Redlines completed 17-Jul - DP

Lot 17 - Duncan's Creek

The Brunswick English Country- LH

NEW HOME INC STRUCTURAL ADDENDUM LEFT HAND	REV #	REF PROJ #	DATE

MESSY KITCHEN, POWER PANTRY FLOOR PLAN OPTION
SCALE: 1/4" = 1'-0" ON 22x34, 1/8" = 1'-0" ON 11x17

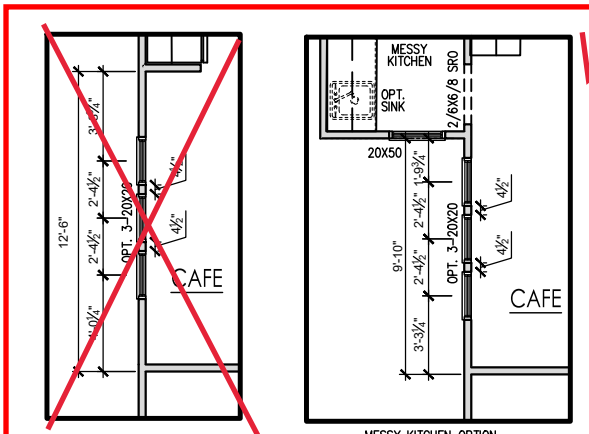
Add sink at Messy Kitchen

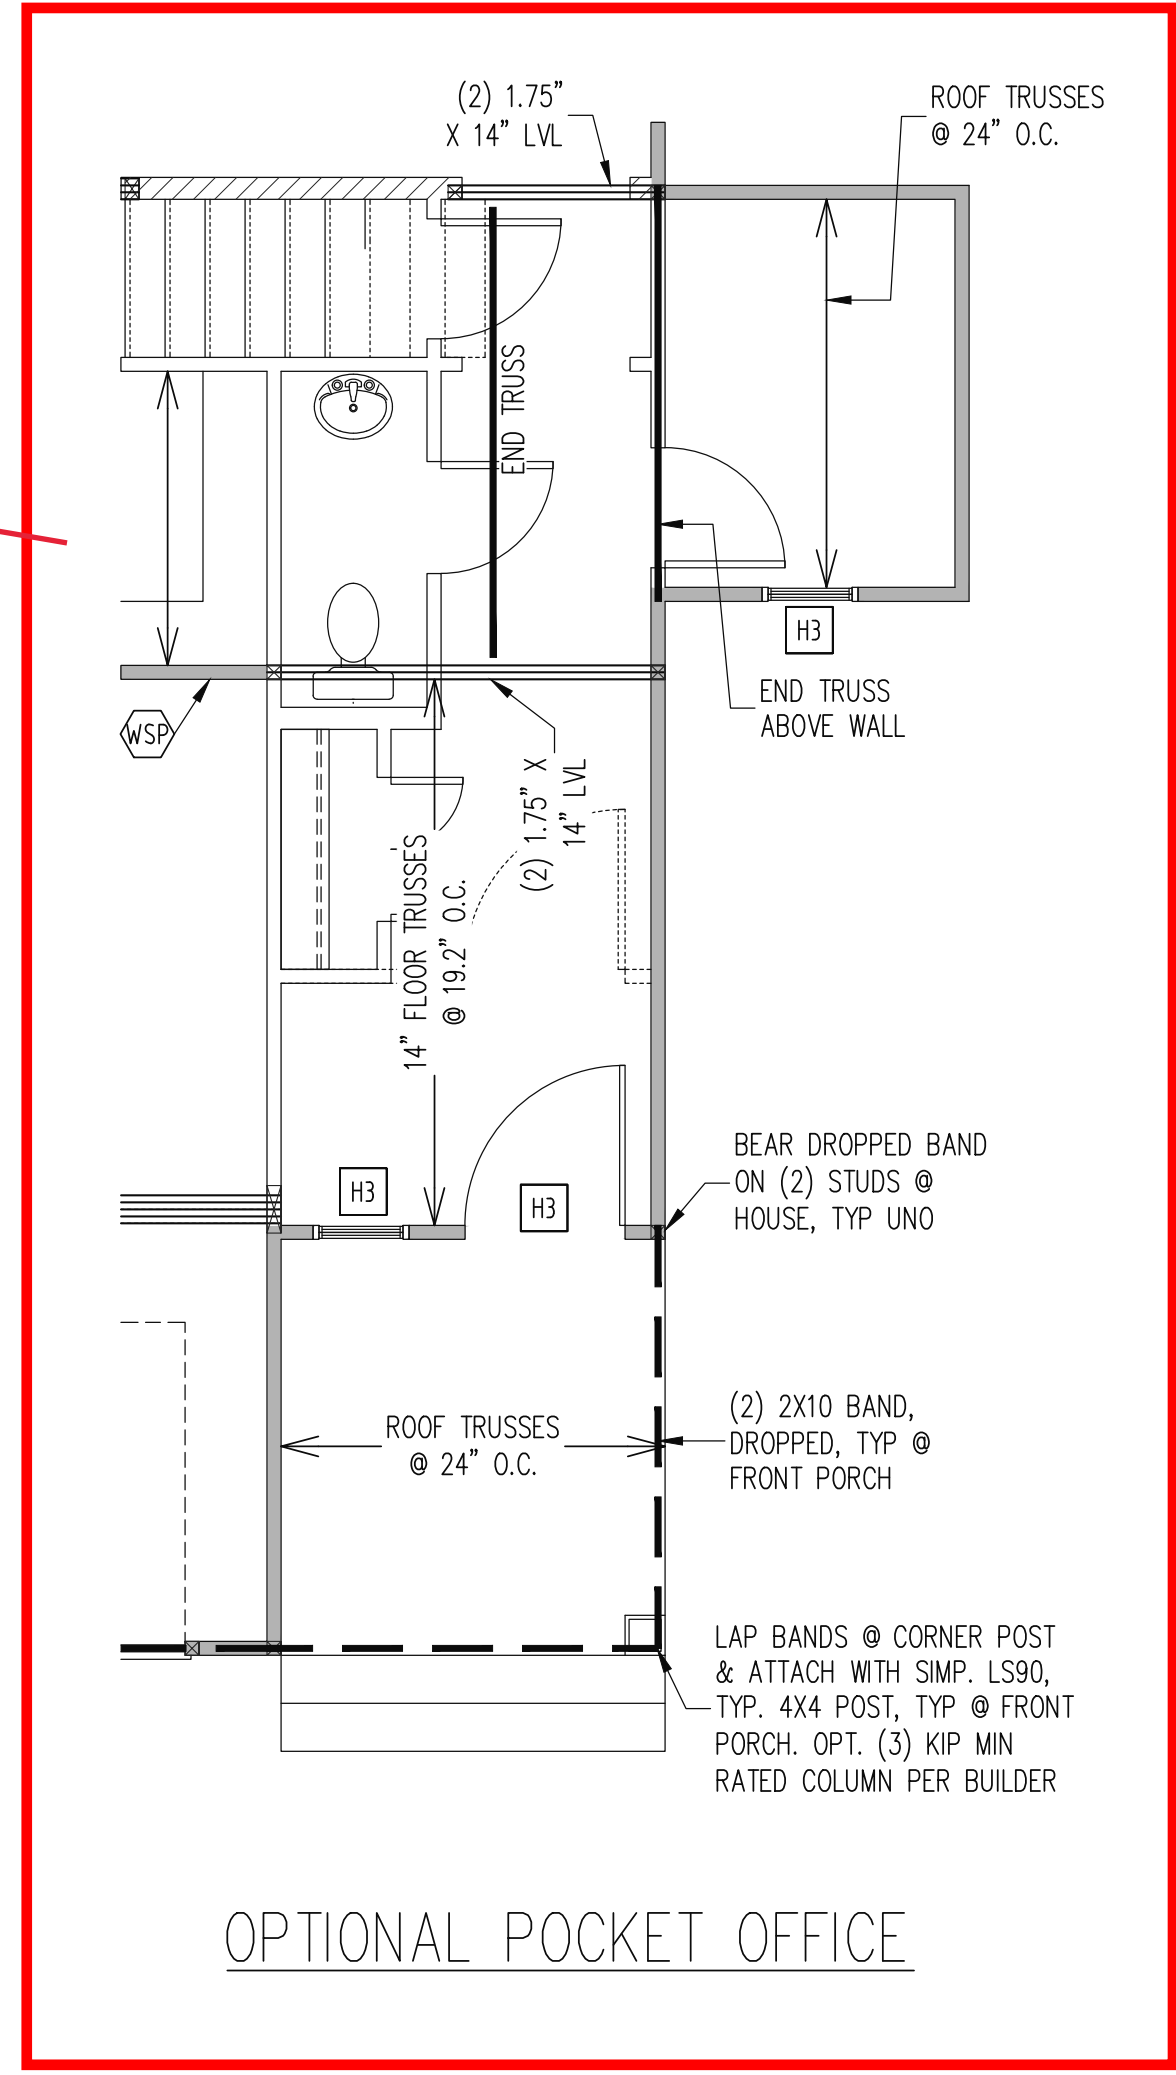
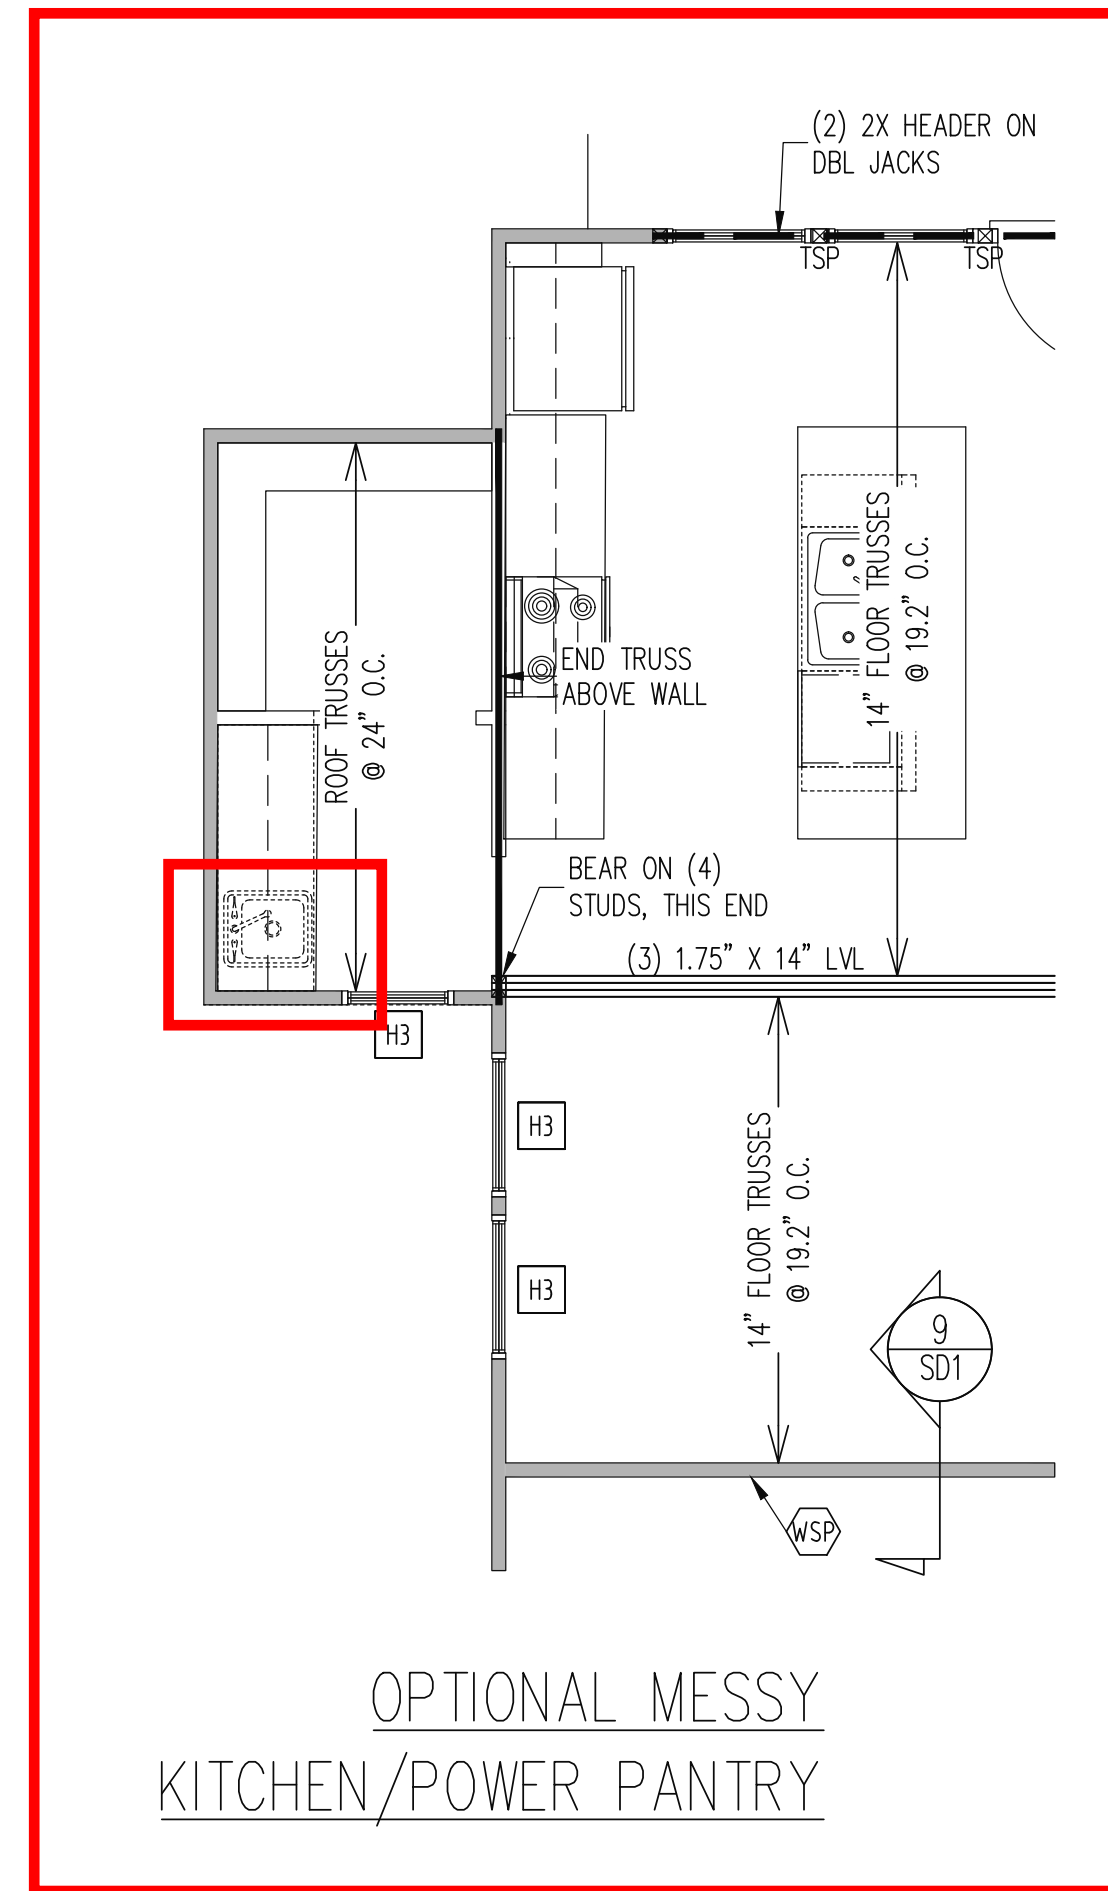
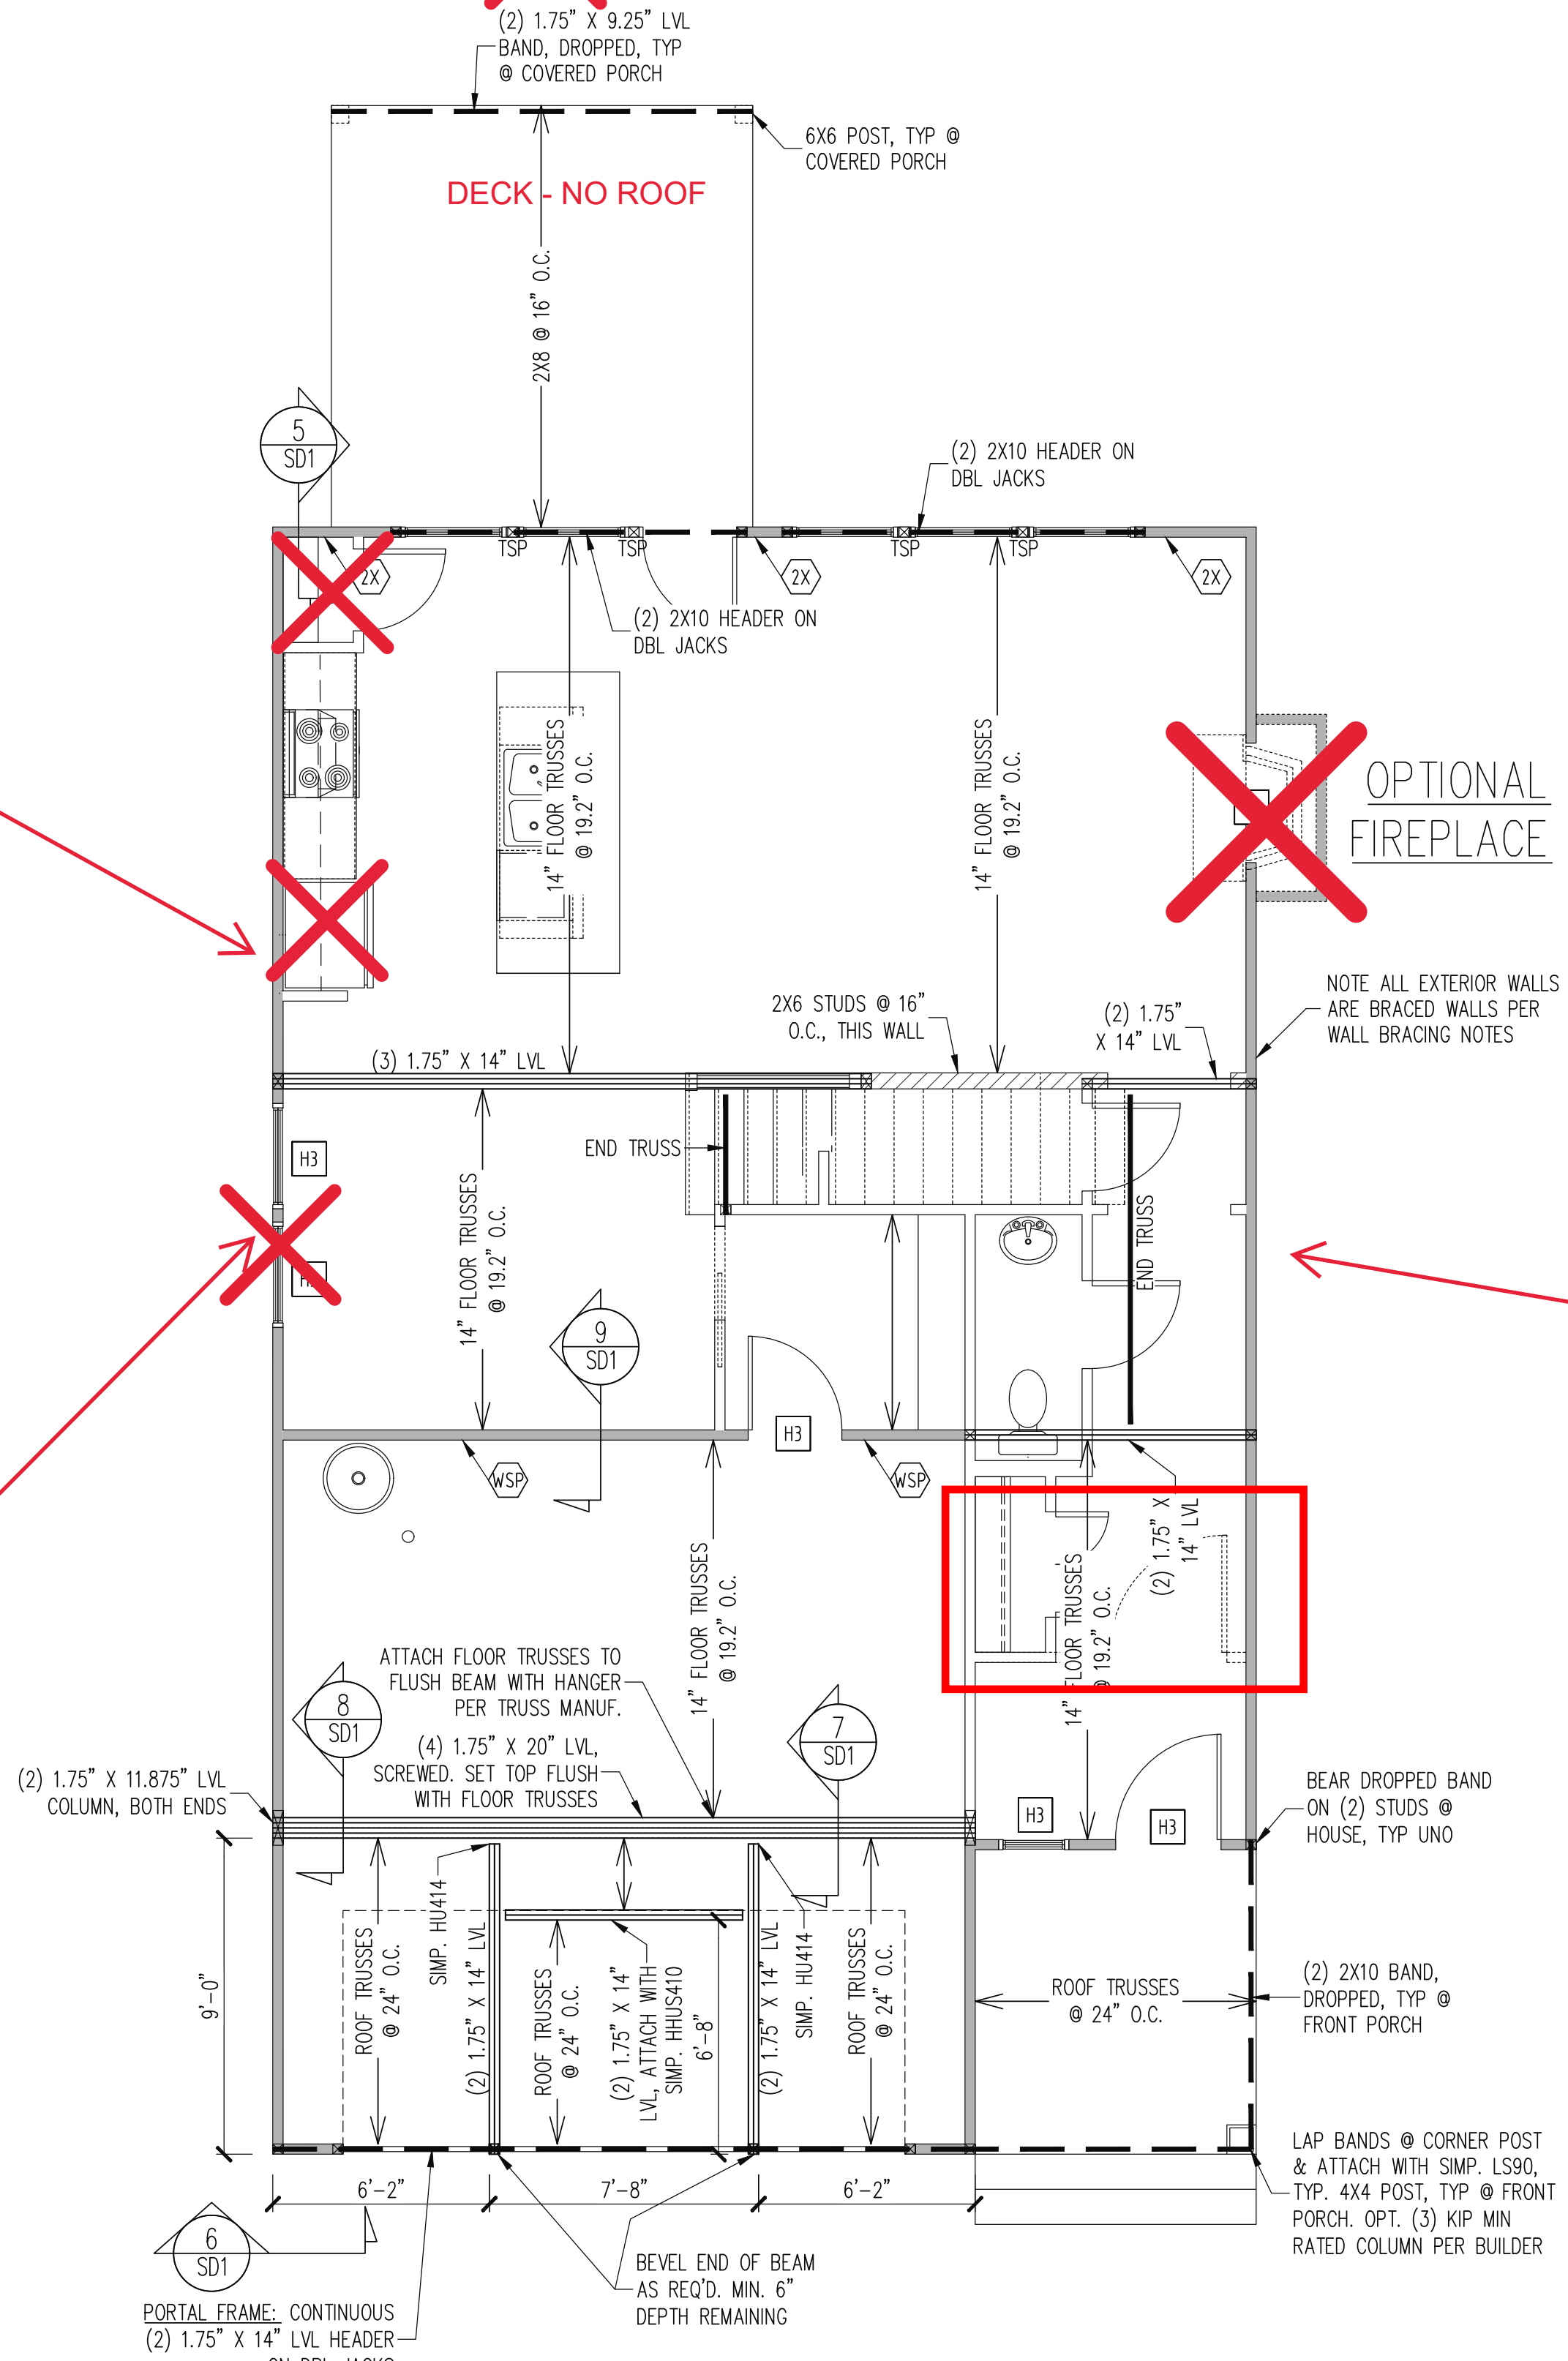
~~OPTIONAL COVERED PORCH~~
